DEPARTMENT OF ENVIRONMENTAL MANAGEMENT  
OFFICE OF WATER RESOURCES  
FRESHWATER WETLANDS PROGRAM  
APPROVED WITH CONDITIONS  
AS SPECIFIED IN THE LETTER OF APPROVAL  
DATED NOV - 4 2010 FILE # 10-0194  
NO CHANGES ALLOWED WITHOUT PRIOR APPROVAL  
APPROVED PLANS MUST BE AT CONSTRUCTION SITE.

PROPOSED OWTS NEW CONSTRUCTION PLAN  
PREPARED FOR  
**COLLEEN STANTON**  
MAP 1-14 BLOCK 40 LOT 54  
CRAIG AVENUE & SUMMERFIELD LANE  
TIVERTON, RHODE ISLAND

REVISIONS: SHEET 1 OF 2 JOB#: 07-095

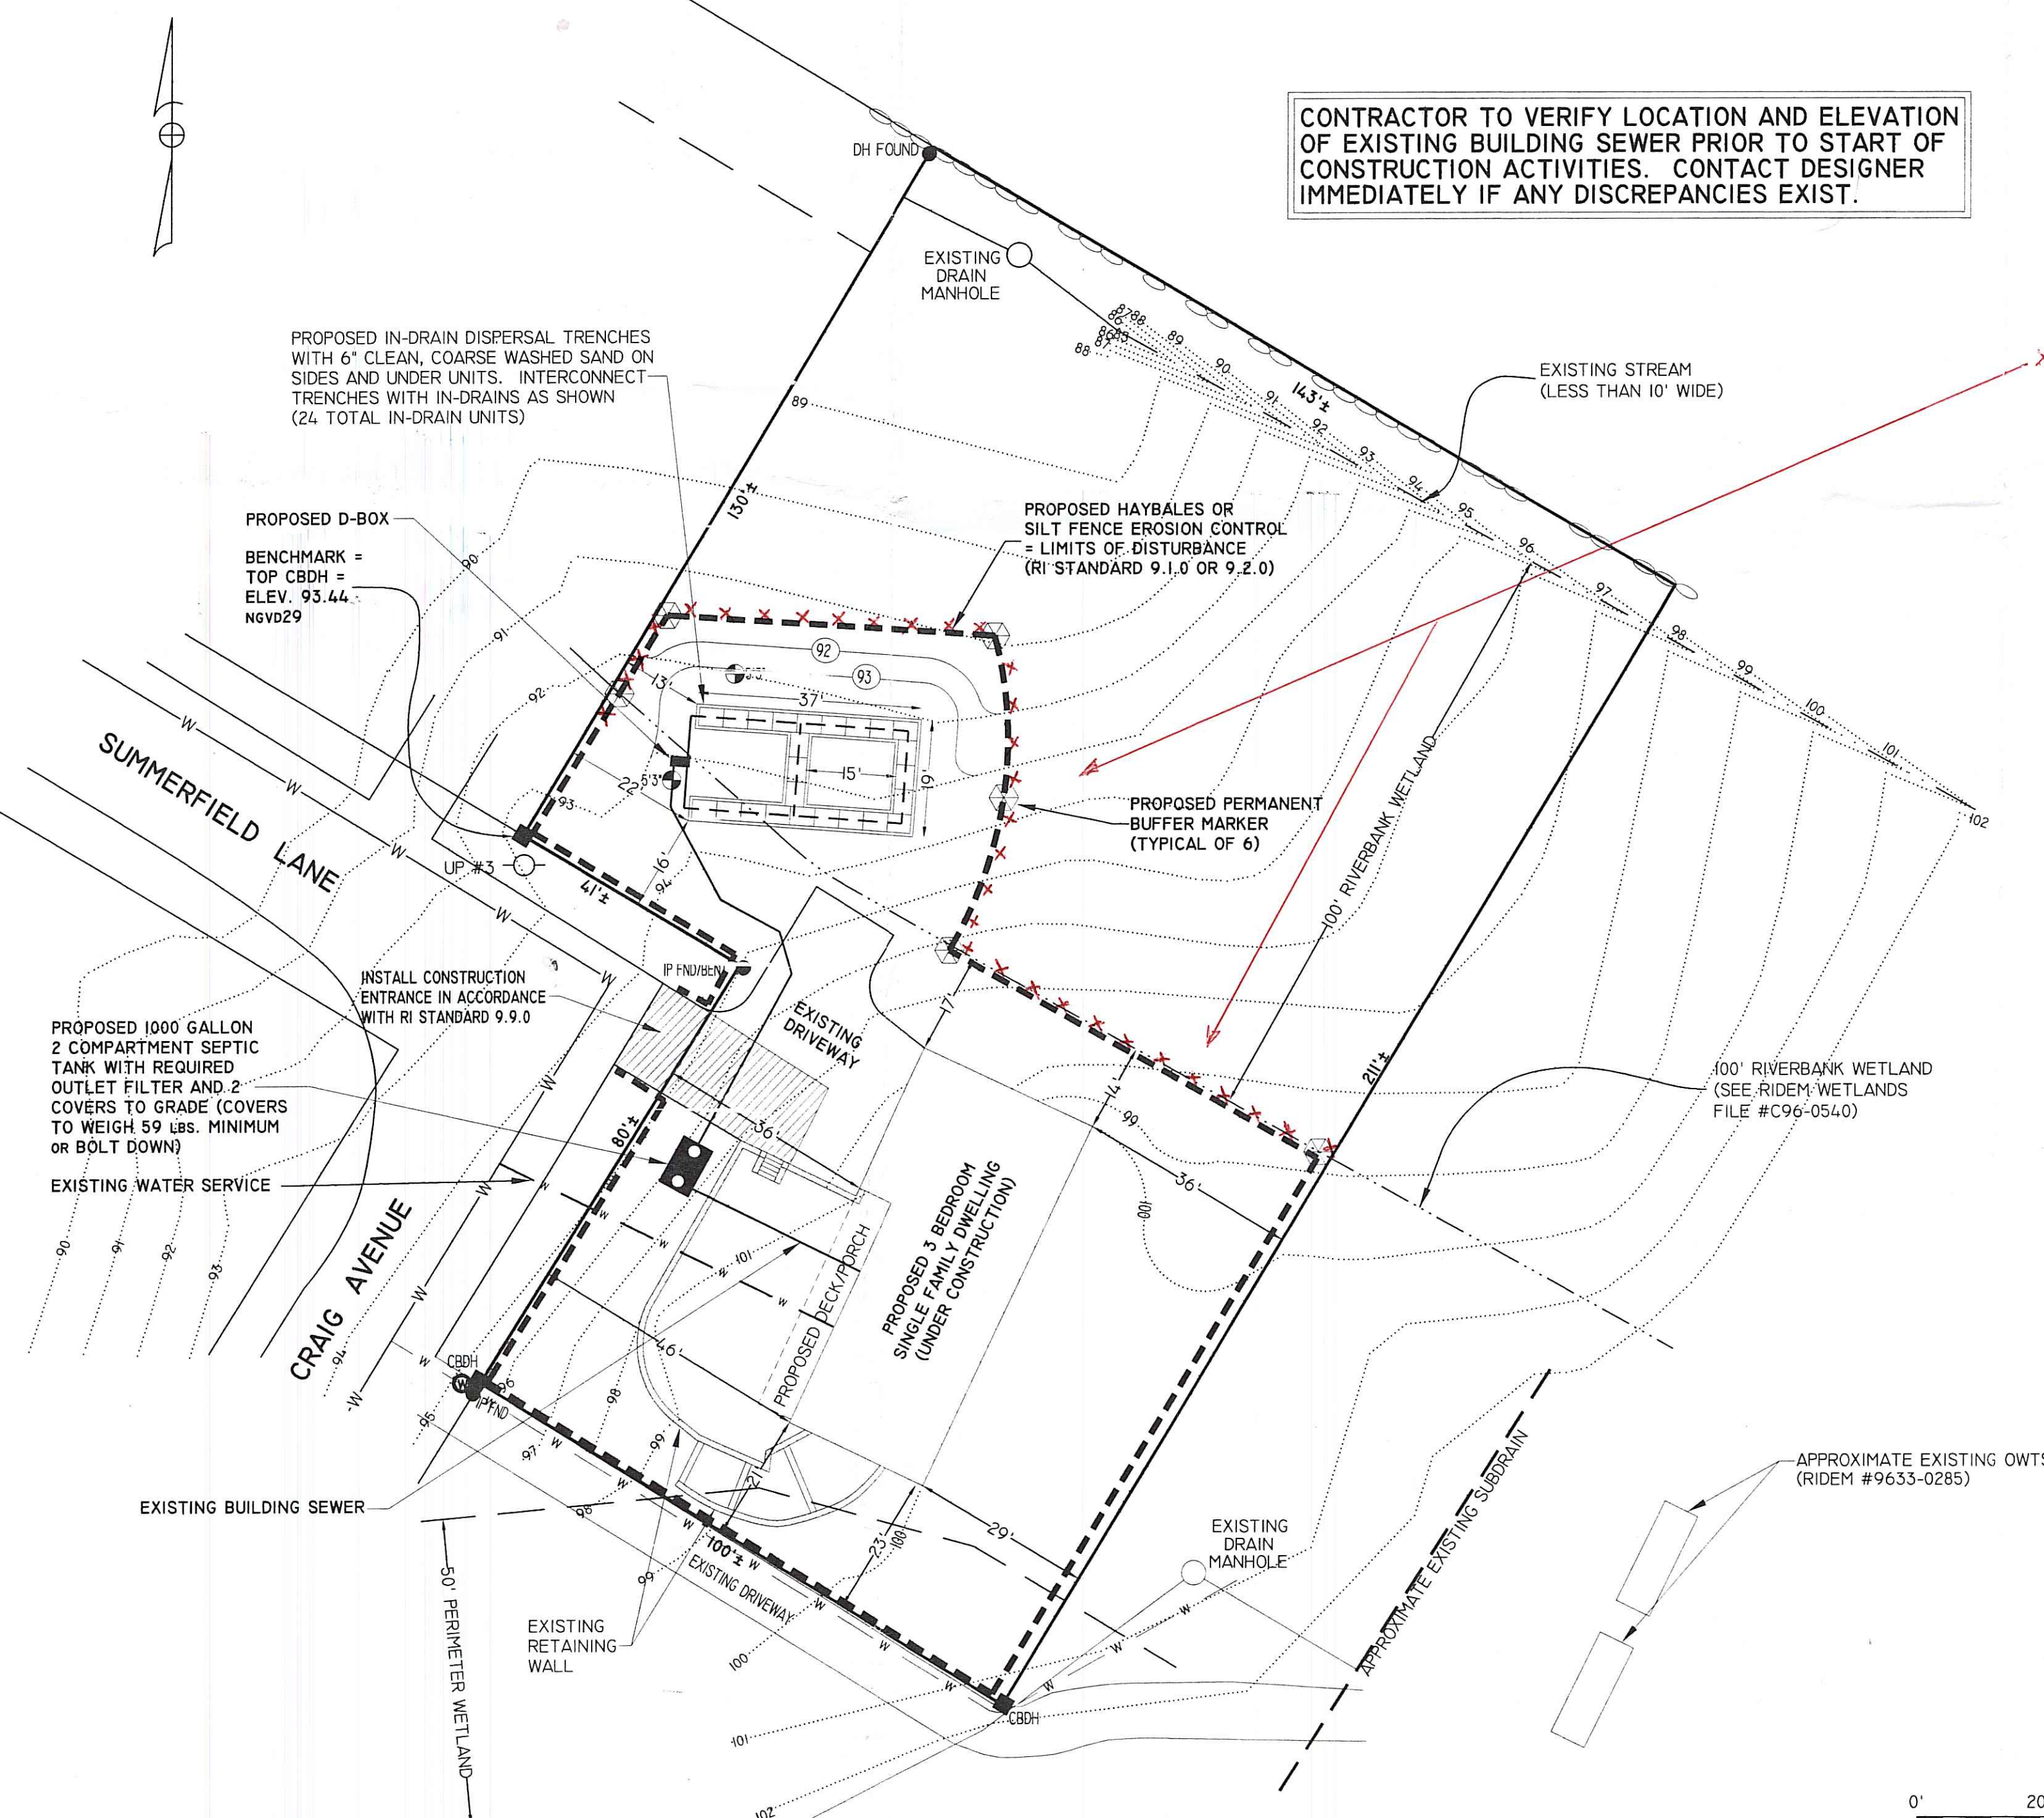
REVISED PER DEM:  
X- PLANT RHODODENDRON SHOUBS (RHODODENDRON MAXILLIMA)  
16 FEET ON CENTER AND 3 FEET HIGH AFTER PLANTING
